Access Compliance Report Public Rights-of-Way (Curb Ramps)

Main Street: OLD_FOOTHILL_BLVD Cross Street: BARRETT_LN Location: W

ADA ID: RPRK211011165758 Ramp Type: Type 4 - Parallel Initial Pass/Fail: Pass Overall Compliance: No Severity Score: 5

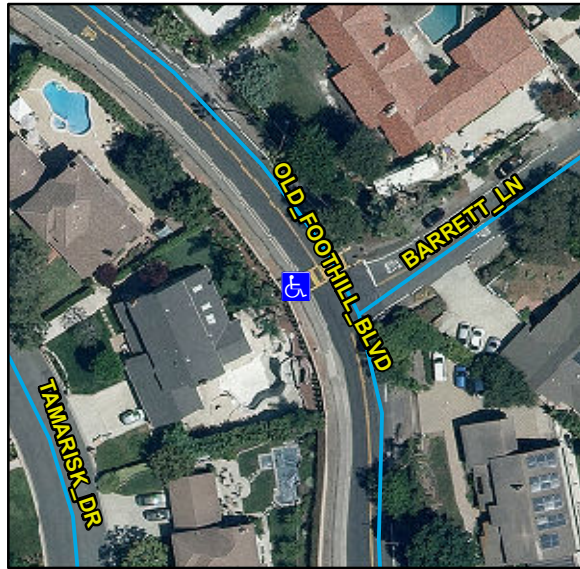
Yes	Ramp Inside Crosswalk 1	Yes	N/A	Ramp Inside Crosswalk 2	N/A
	Crossing 1 Slope (%)	14.1		Crossing 2 Slope (%)	N/A
	Crossing 1 Cross Slope (%)	1.5		Crossing 2 Cross Slope (%)	N/A
Yes	Gutter Ponding	No	Yes	Curb Slope	5.3
Yes	Gutter Lip Height (in)	0		Road Run Slope (%)	N/A
No	Gutter Run Slope (%)	10.1		Road Cross Slope (%)	N/A
Yes	Gutter Cross Slope (%)	0.3	Yes	Perpendicular Joint Present	Yes
Yes	Overall Surface Condition	Acceptable			
	Cross Gutter Present?	No		Spandrel Present?	No
	Replace Cross Gutter?	N/A		Replace Spandrel?	N/A

Possible Solutions:

Remove & Replace Gutter.

R304.5.4, STD 1115
